**SNS-OPM-ATT 2.B-10.a.  
Unreviewed Safety Issue (USI) Evaluation Form**

**Modifications to the TPPS to resolve the Primary Shutter Reopening Abnormality and removal of the Maintenance Key Switches.**

Figure 1 Maintenance Key Panel to be removed

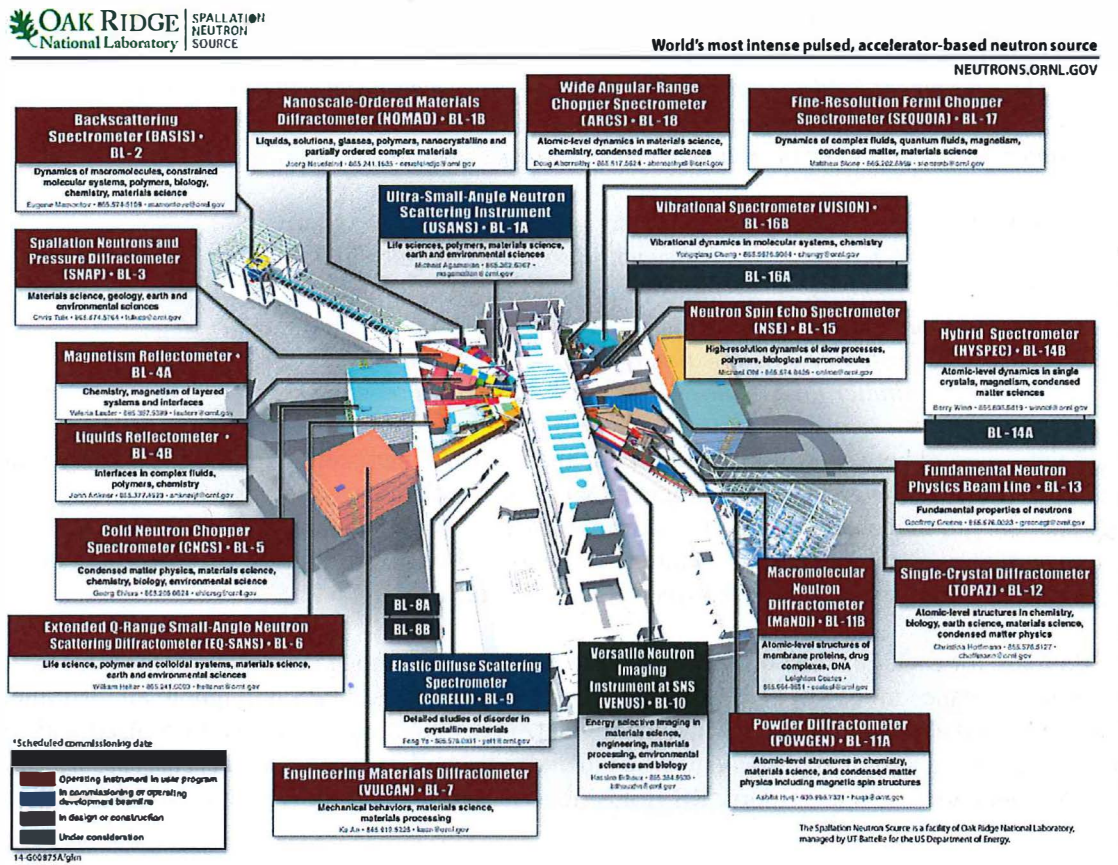
- a) Modify the TPPS division A and B PLC programs to remove logic referencing the maintenance keys and maintenance mode.
  - b) Remove the maintenance key panel from TPPS rack PPS\_TGT: CAB01.

- c) Remove the PLC input wiring associated with the maintenance mode key panel.

**Figure 4** Wiring for interim relay modification is marked for easy removal.

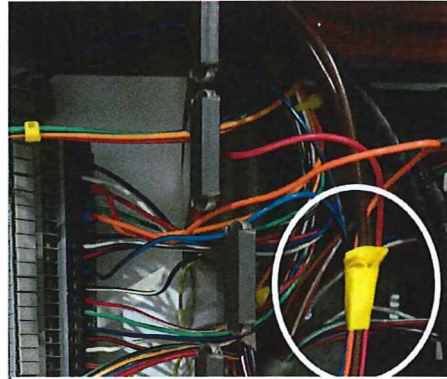
Hardware modifications include removing the relays and associated wiring installed in July 2014. The original installation was documented through configuration managed drawings. These drawings will guide the removal of the relays and wiring. The wiring associated with the relay installation is separated and marked to allow easy identification for removal (see Figure 4).

**Figure 5** Prototype TPPS PLC A logic showing the use of the BL-1A and BL-1B "Access OK" bit to inhibit the primary shutter OPEN command for beamline 1. The "Access OK" signal is a summary of all faults from a given instrument PPS.

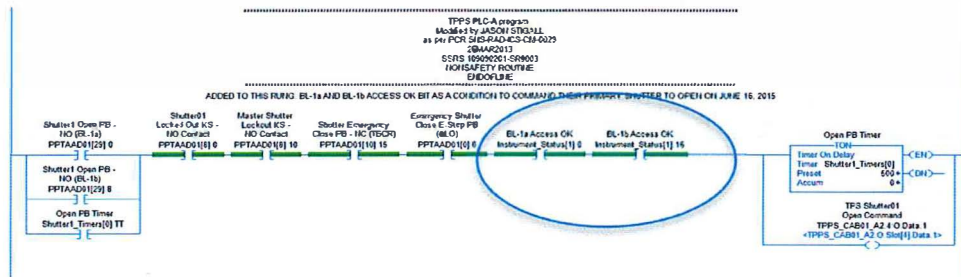
PLC program modifications will involve combining the Access faults and System fault bits into a single status bit, one for each of the individual dual beam lines, which indicates all faults for a respective beam line are in a safe state. This bit will be used to inhibit the primary shutter OPEN command if there is a fault on either of the two downstream beamlines.

*Note: The TPPS PLC A logic already contains this summary bit for each instrument beamline. The scope of the logic change will be to use the existing bits in the primary shutter OPEN logic string. Figure 5 is a representation of this addition.*

Figure 6 Typical decommissioning drawing used to remove the maintenance mode key panel and associated wiring.

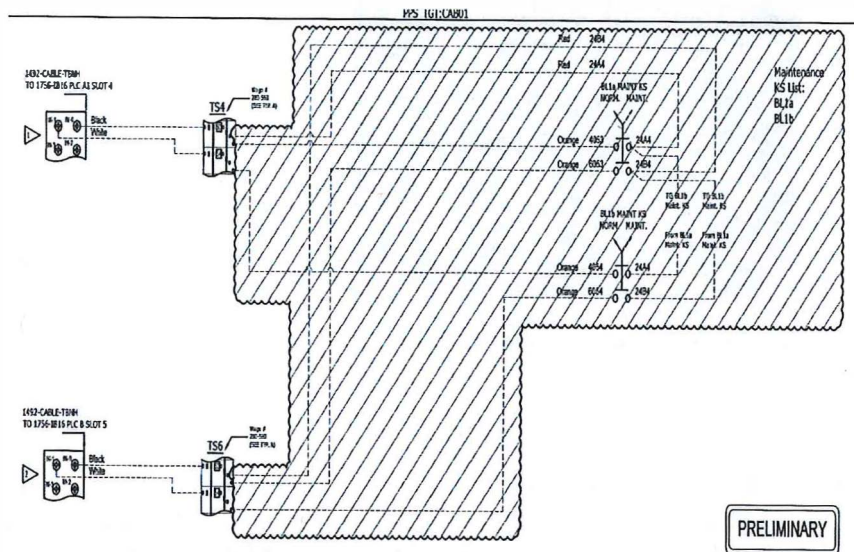
Hardware modifications involve removing the TPPS maintenance key switch panel and associated wiring from cabinet PPS\_TGT:CAB01. Because the revised drawings showing the wiring between TGT:CAB01 and the TPPS reflect the absence of key switches, the PPS Systems Engineer generated special

decommissioning drawings for each item to be removed. Figure 6 shows an example of the decommissioning drawing for the 1A/1B maintenance switches. These drawings are intended to guide the removal process only. The de-installation drawings are:

Figure 7 TPPS logic showing the "Maintenance Mode" bit that will be eliminated from the TPPS logic.

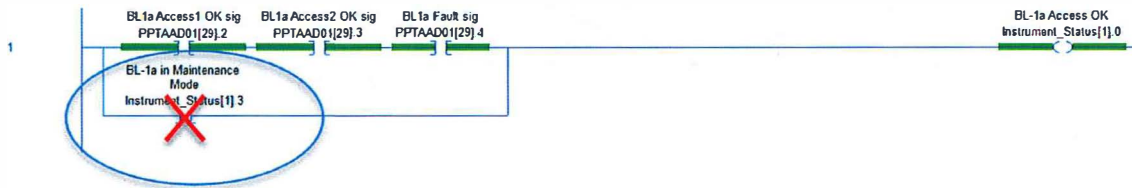
The scope of software modifications is limited to removing all instances of the ‘maintenance mode’ within the TPPS PLC A and PLC B logic. Figure 7 shows a typical instance of the Maintenance Mode for beamline 1A that will be removed from the TPPS logic. There are no software modifications that affect the TPPS functionality or credited safety functions described in the FSADs.
